N5230A-03

S E R V I C E N O T E

N5230A Option 020/025, 120/125, 220/225, 240/245,
420/425, 520/525 PNA-L Microwave Network Analyzers

Figure 1: A3 Front Panel Interface Board Assy without the Bracket

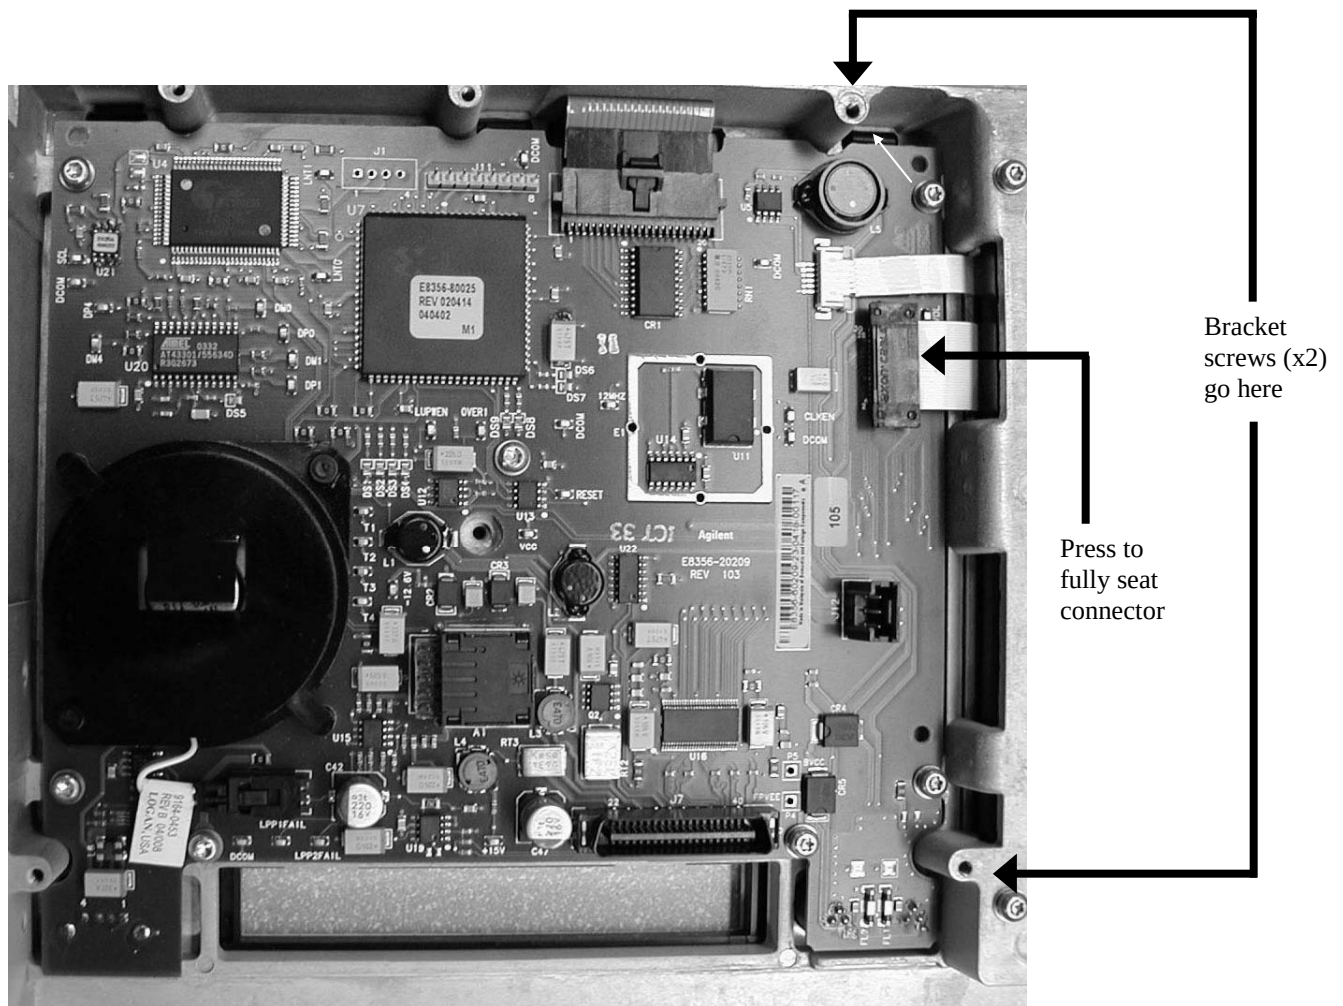
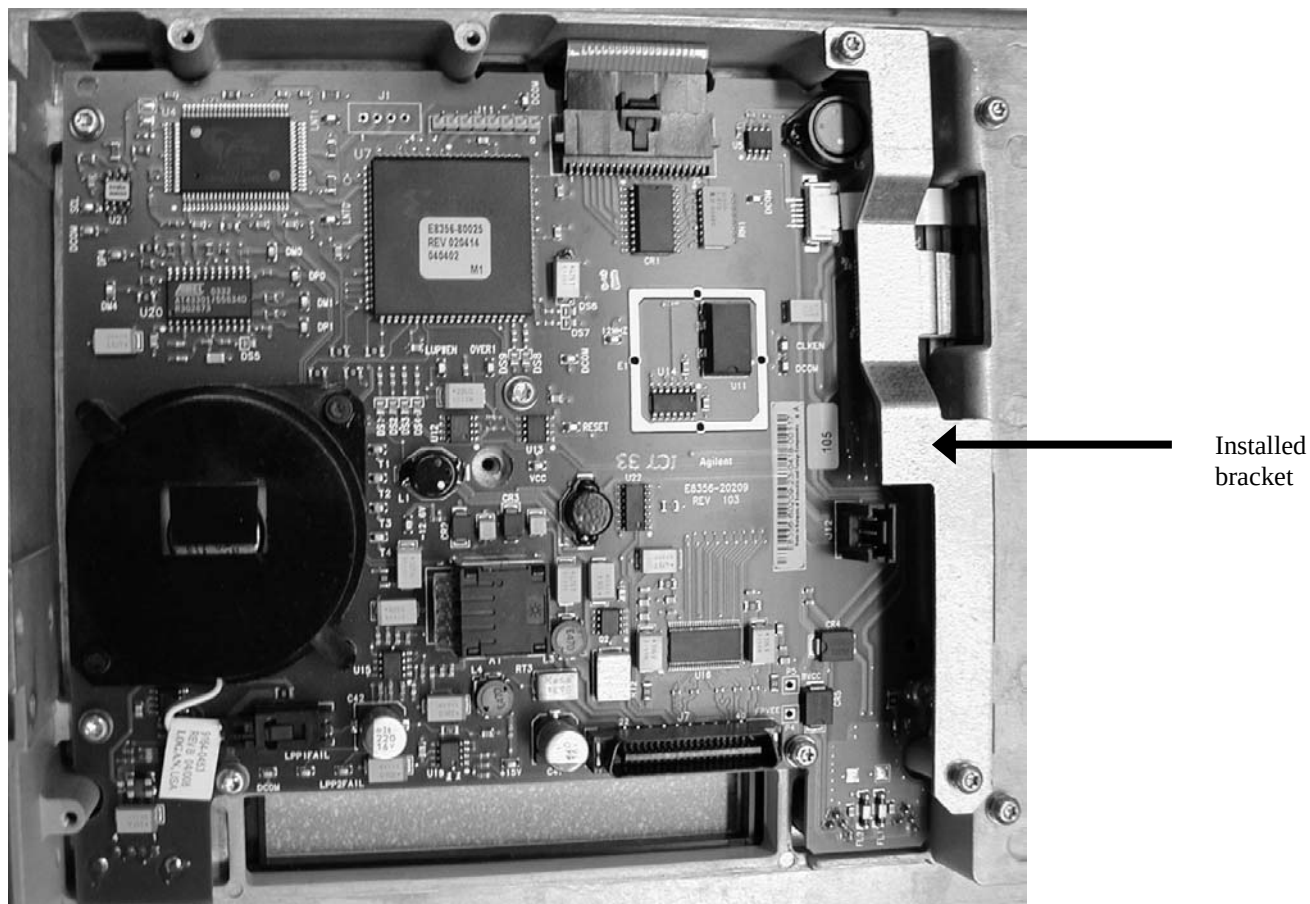
A connector of the ribbon cable (Agilent part number 8120-8409) that joins the front panel display to the front panel interface board can loosen, causing a display failure, unless a new bracket is installed. Because the failure rate has been very low, it is recommended that the bracket be installed only when there is an additional reason to remove the PNA front panel.

1. Refer to Figure 1 in this document:
 - Press down firmly on the ribbon cable's black connector.
 - Locate the two tapped holes for the bracket screws.
2. As shown in Figure 2 in this document, position the bracket so that its holes line-up with the two holes you located in the previous step.
3. Hand-start the two screws, and then torque both to 9 in-lbs.
4. Reinstall the PNA Front Panel by following the Service Guide instructions in the "Replacement Procedure." This is located on the same page as the "Removal Procedure" used previously in step 7.
